SCDF

Common Audit Issues

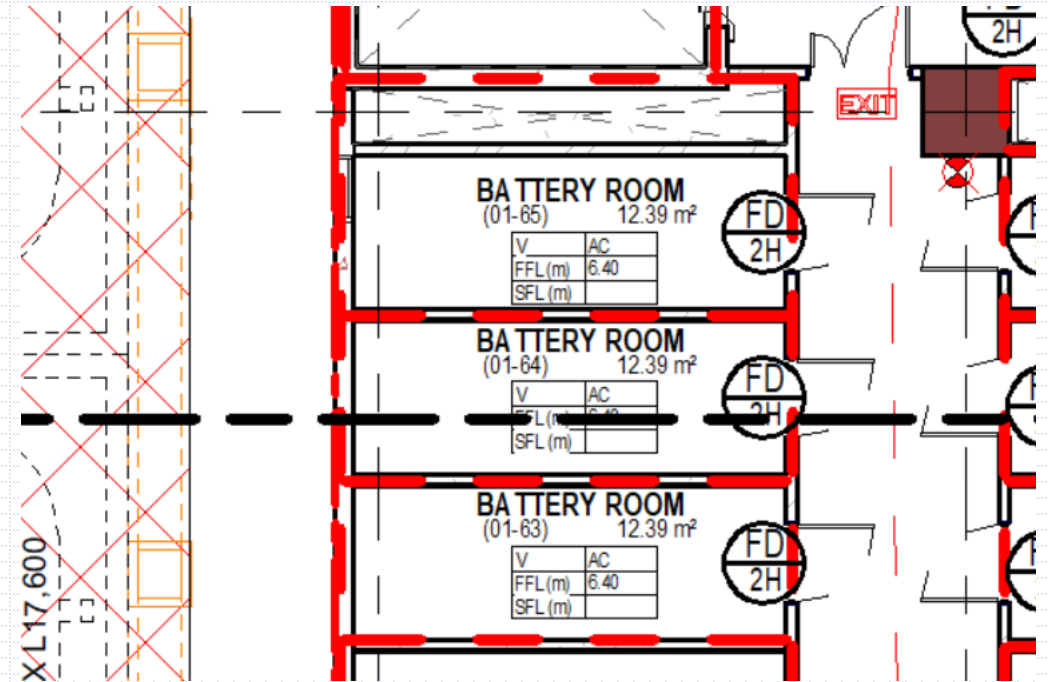
- To provide MAQ (for lab & minor storage), including information such as habitable height, storey, etc.
- To list the size of container/bottle/package/cylinder
- Fire resistance rating of FM safety cabinet
- Include endorsement to codes where relevant e.g. NFPA 55

10. THE MAXIMUM ALLOWABLE QUANTITY (MAQ) FOR STORAGE PER FLOOR ALLOWED SHALL BE 2L/M² OF FLOOR AREA PER FIRE COMPARTMENT.

11. THE MAXIMUM ALLOWABLE QUANTITY (MAQ) SHALL BE 100% OF STORAGE ALLOWED SHALL BE 100% OF STORAGE ALLOWABLE FOR 1ST TO 3RD STOREY AND 75% OF STORAGE ALLOWABLE FOR THE 4TH STOREY LEVEL.

THE HABITABLE FLOOR HEIGHT FOR THIS BUILDING IS LESS THAN 24M HIGH.

Cl.4.2.1a.

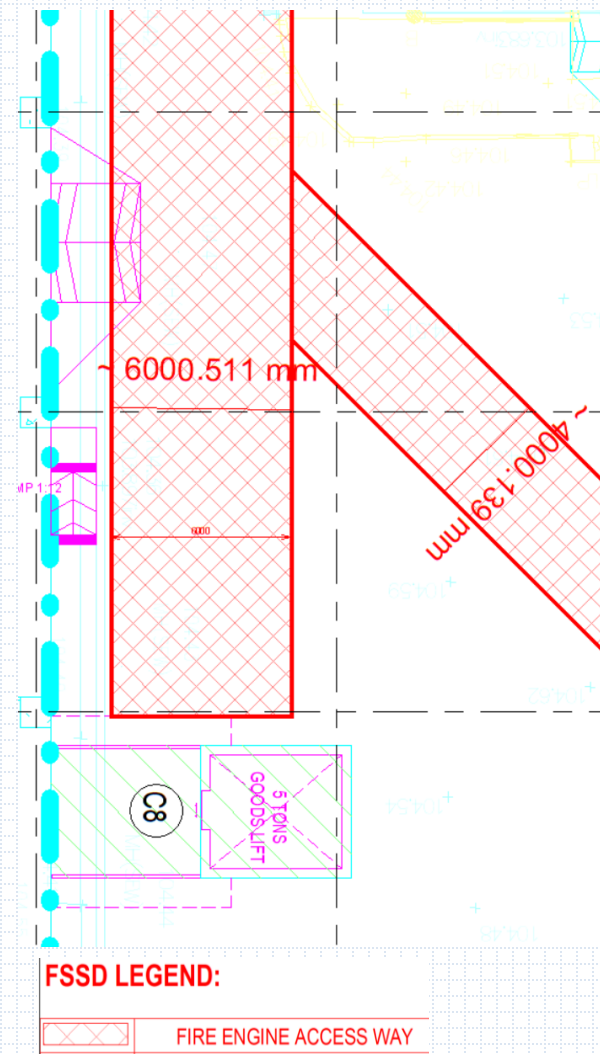
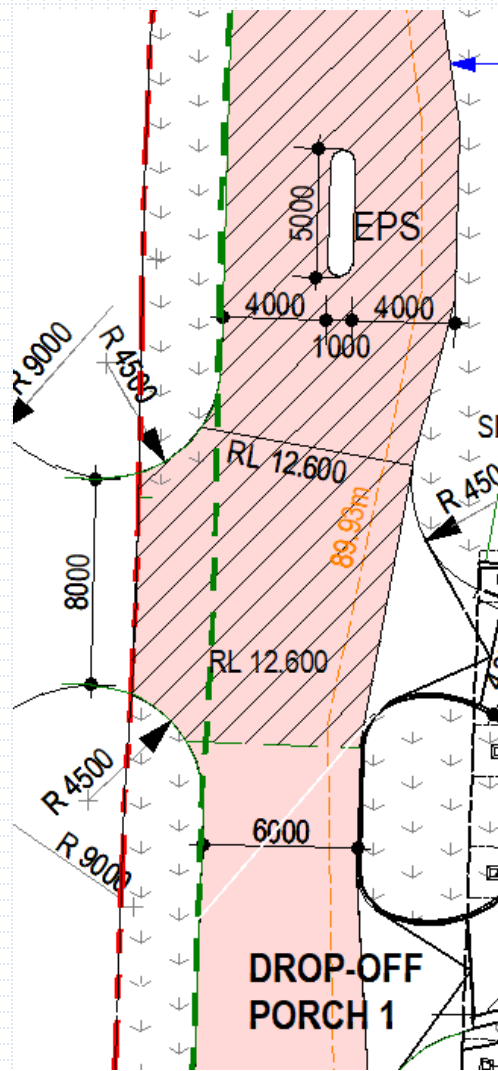
- Different types of FEAway or road not clearly indicated
- Symbols on plan (hatched and unhatched) do not tally with Legend (unhatched only)

Note: Road width of 4m and cannot be FE Away. Road with overhead structure excluded from provision of FE Away.

Cl.4.2.2k.

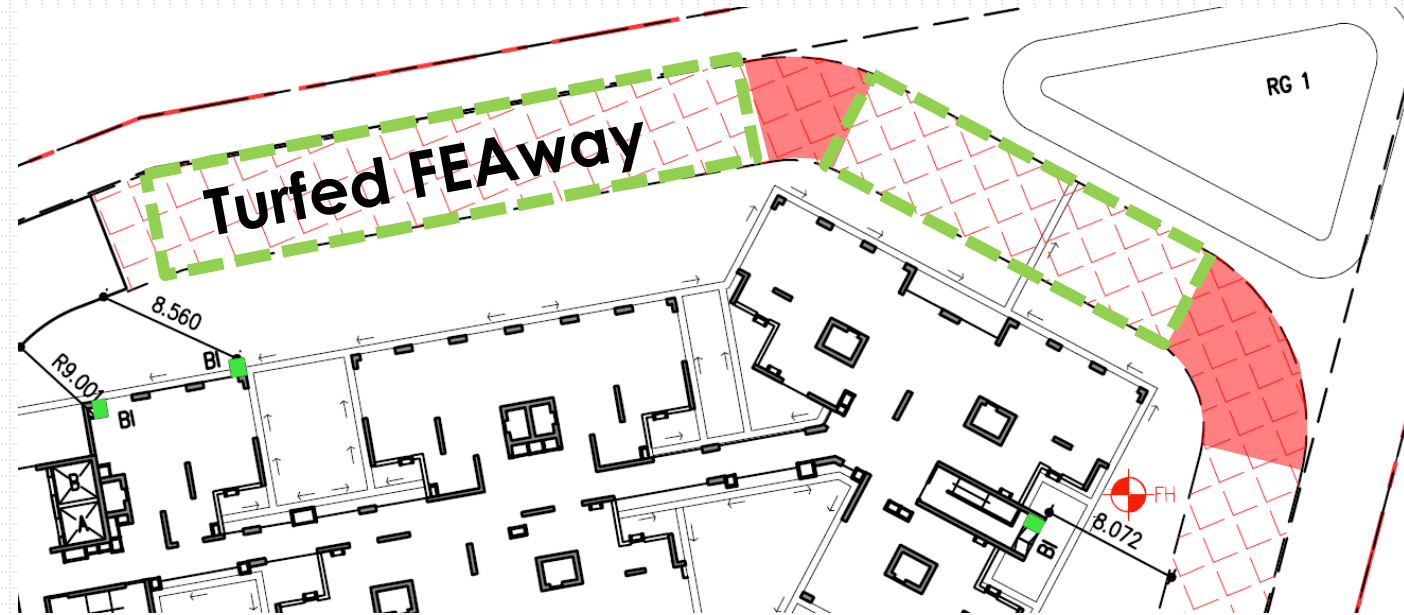
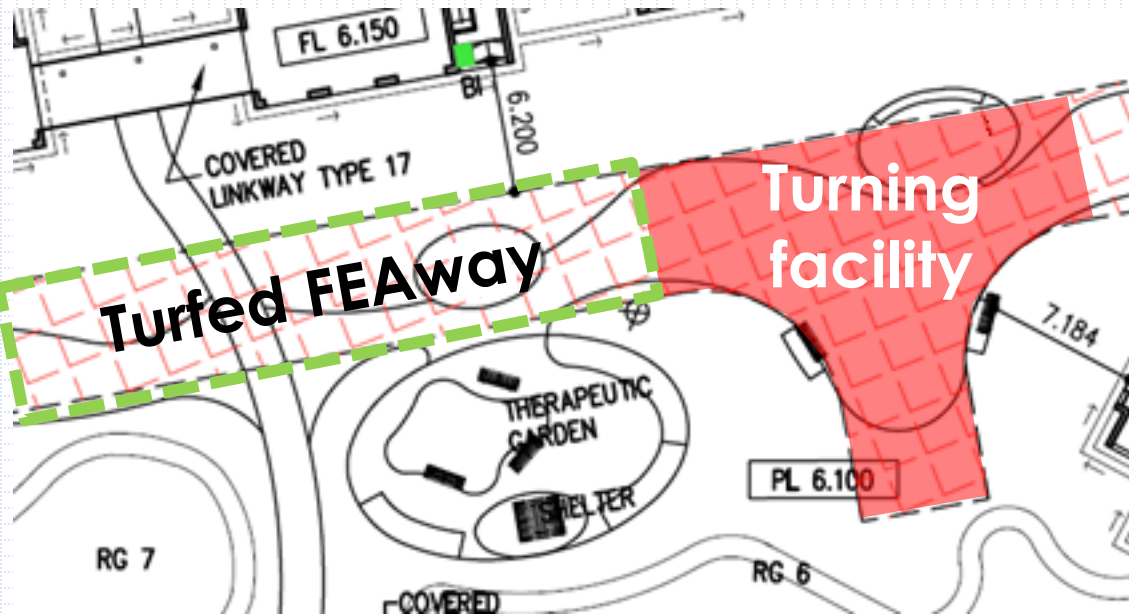
❖ Mistake: Turfed FEAWay/road is not straight

Turfed FEAWay along
bend in road

Cl.4.2.2k.

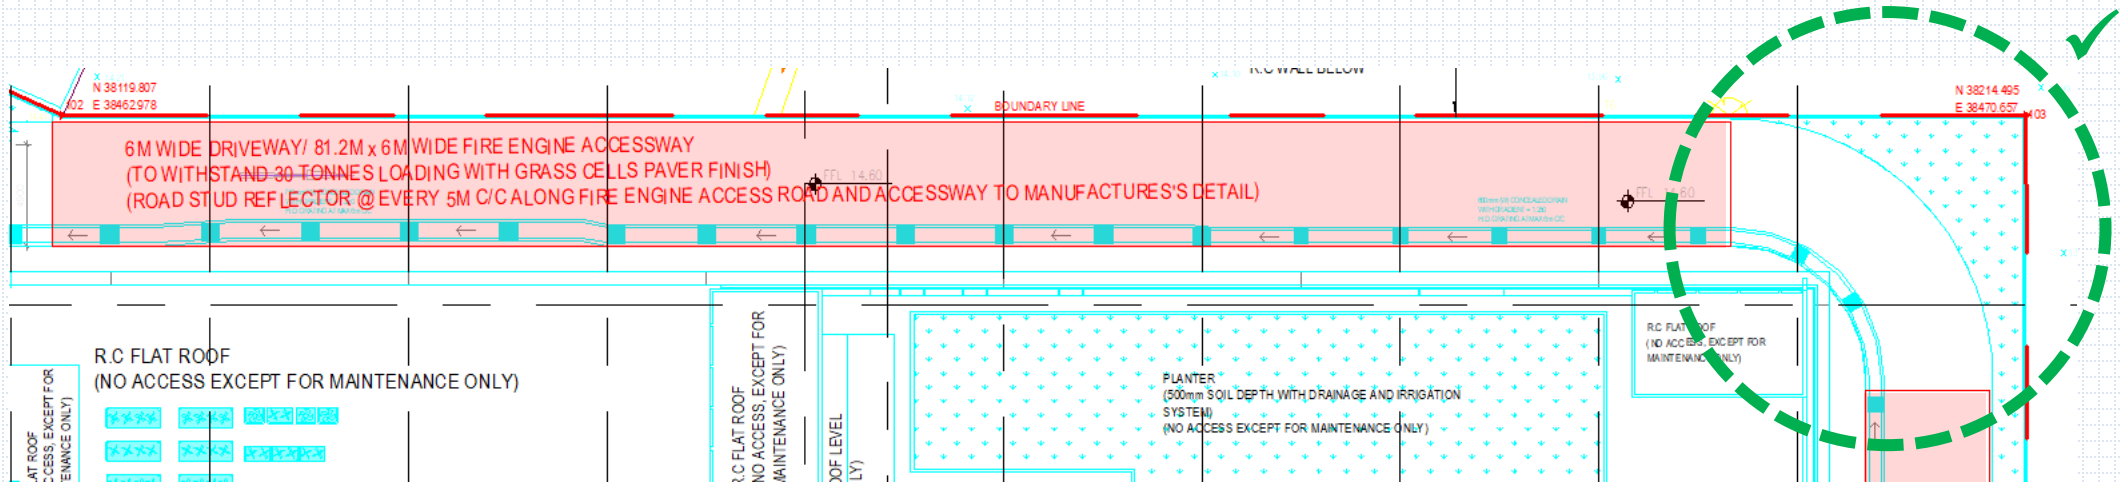
❖ Correct example

- Turfing is only confined to the straight stretch of the FEAWay

Cl.6.1.2a.

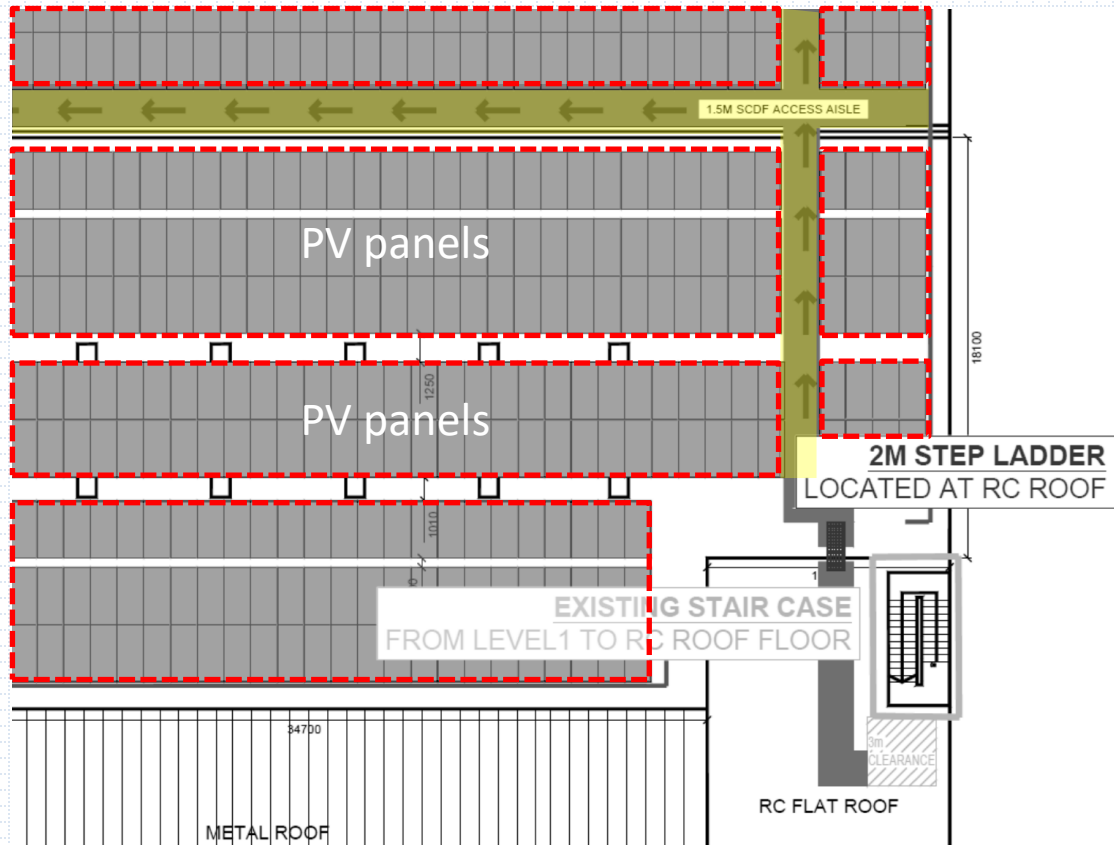
- ❖ Mistake: non- provision of hose reel and extinguisher

Cl.6.2.8d.(3)

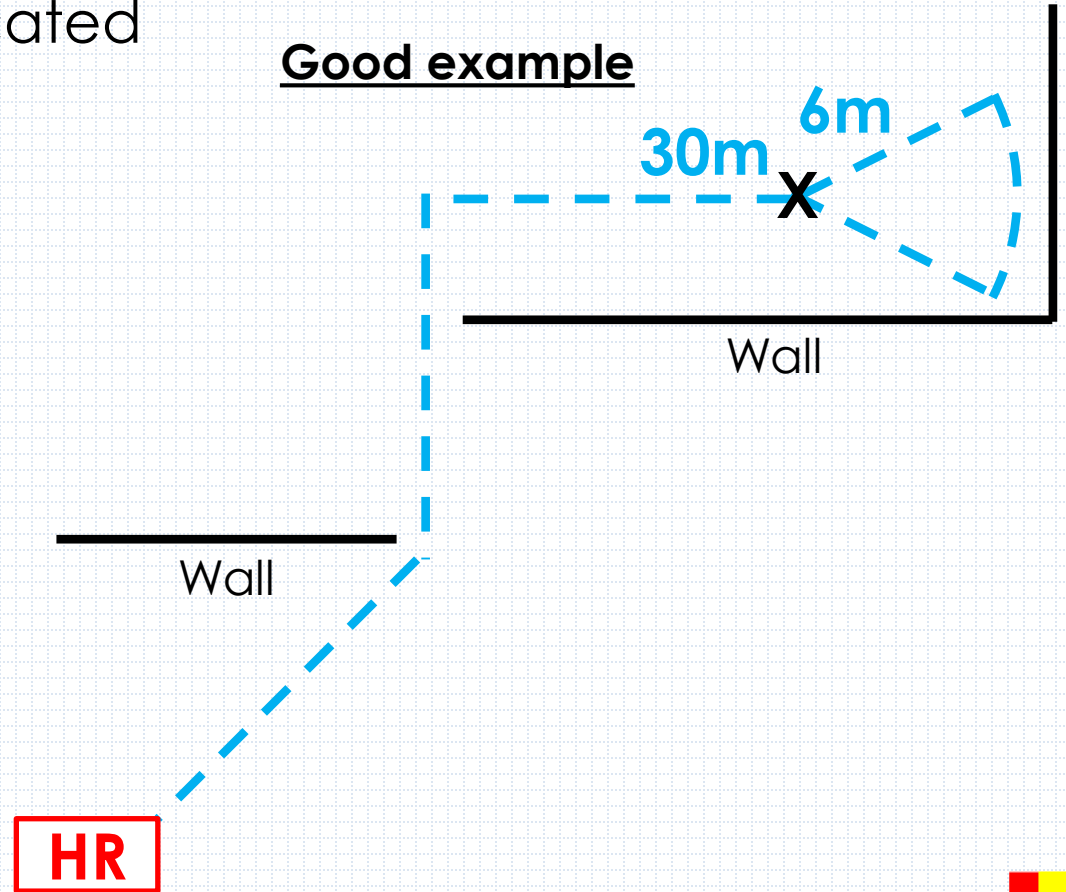
- ❖ Hose reel coverage cannot pass through obstacles
- ❖ The last 6m shall be a straight throw (indicated by an arc of 6m radius)

Cl.6.4.5

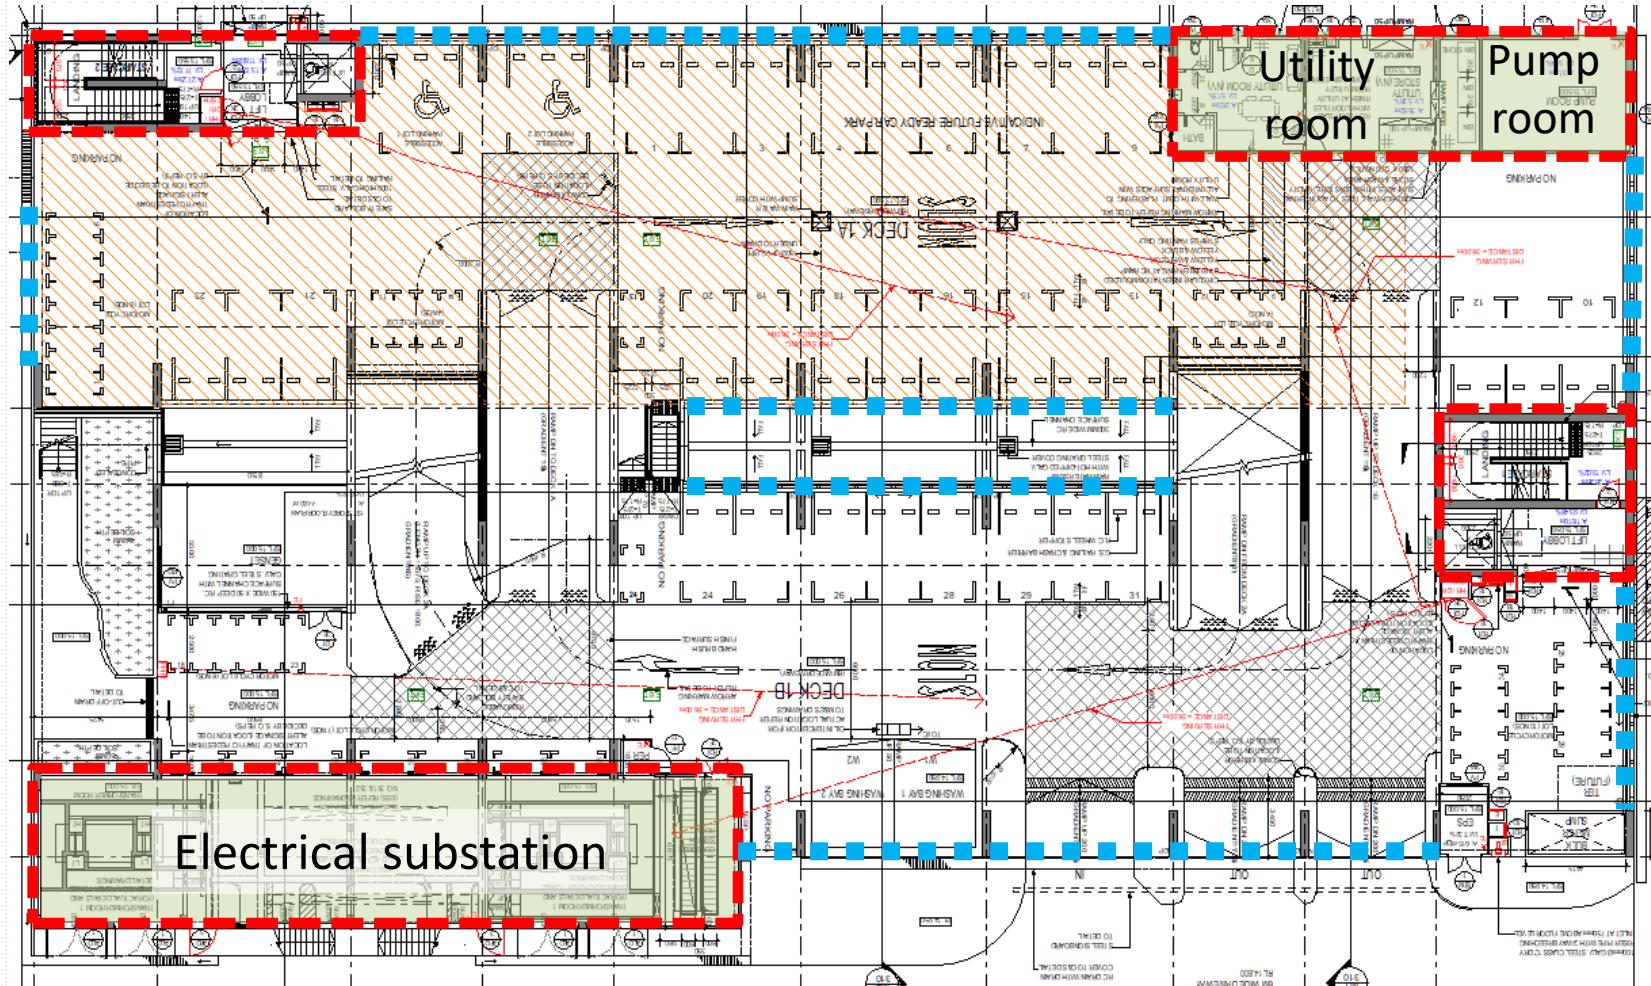
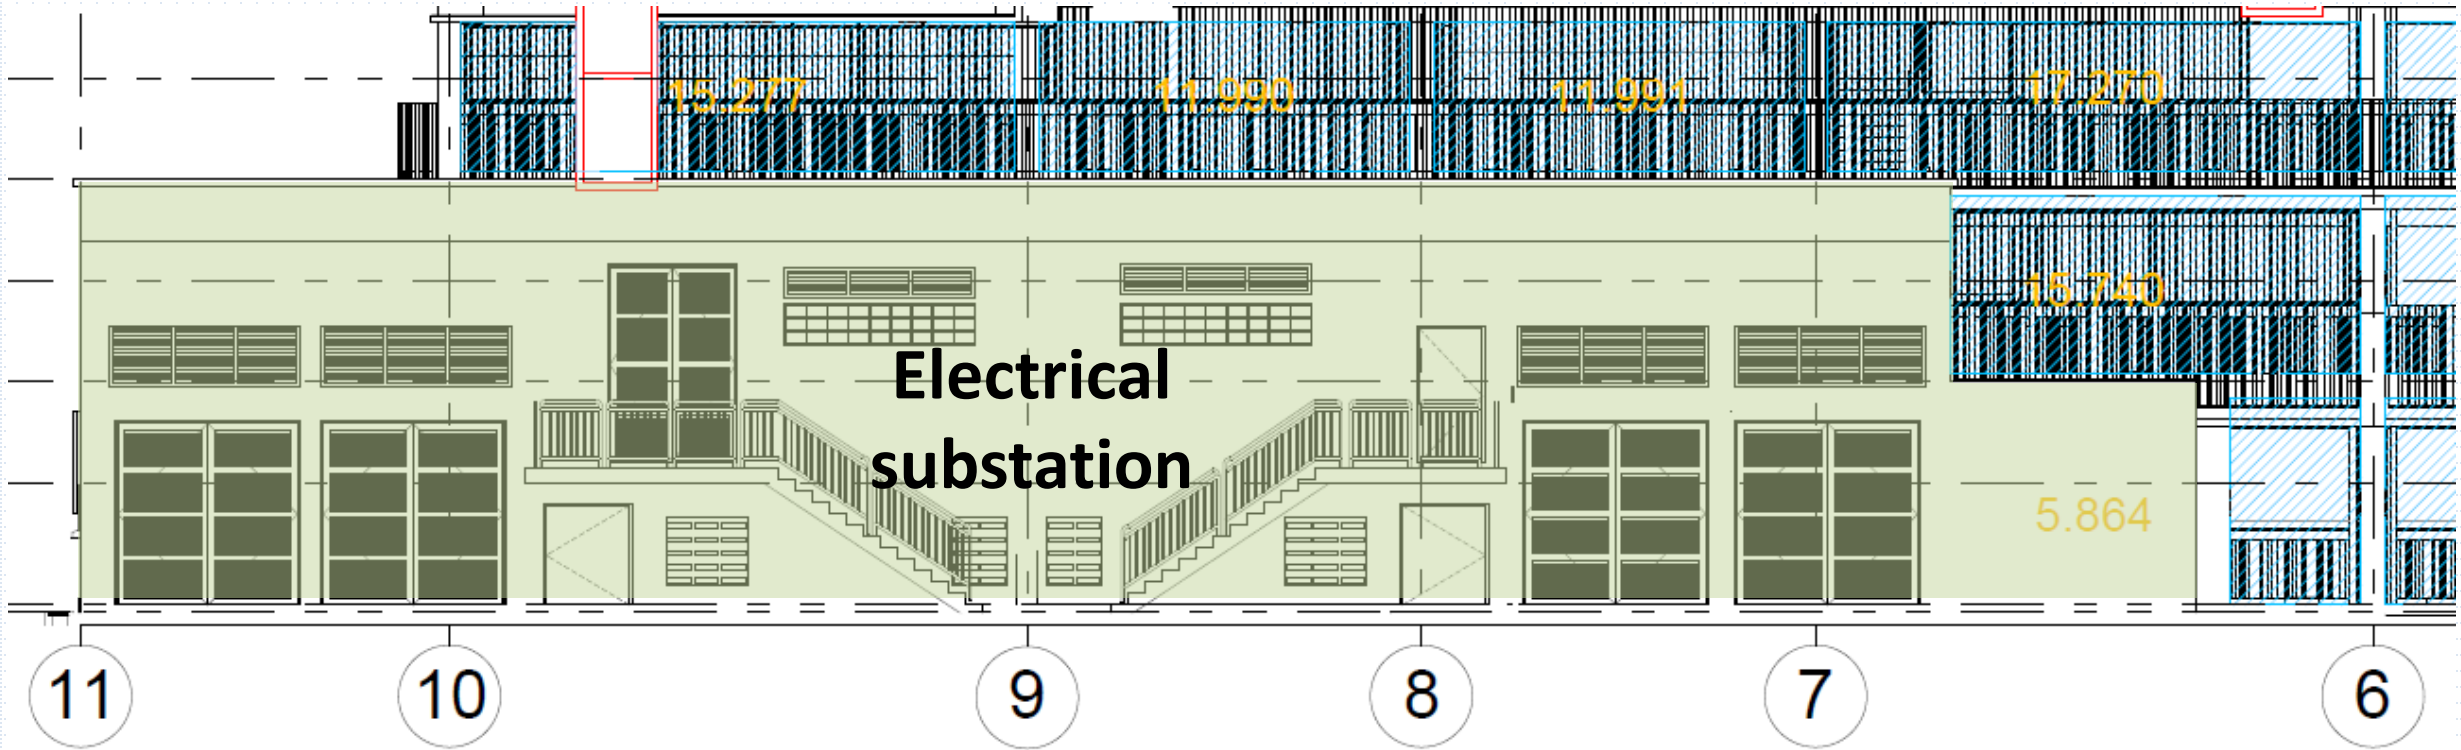
❖ Mistake: Rooms and enclosed spaces along building perimeter are not taken into account when determining if MSCP meets ventilation requirements (Cl.3.2.8). The following are considered as obstruction to ventilation

- Electrical substation
- Utility room
- Utility store
- Pump room
- Staircase
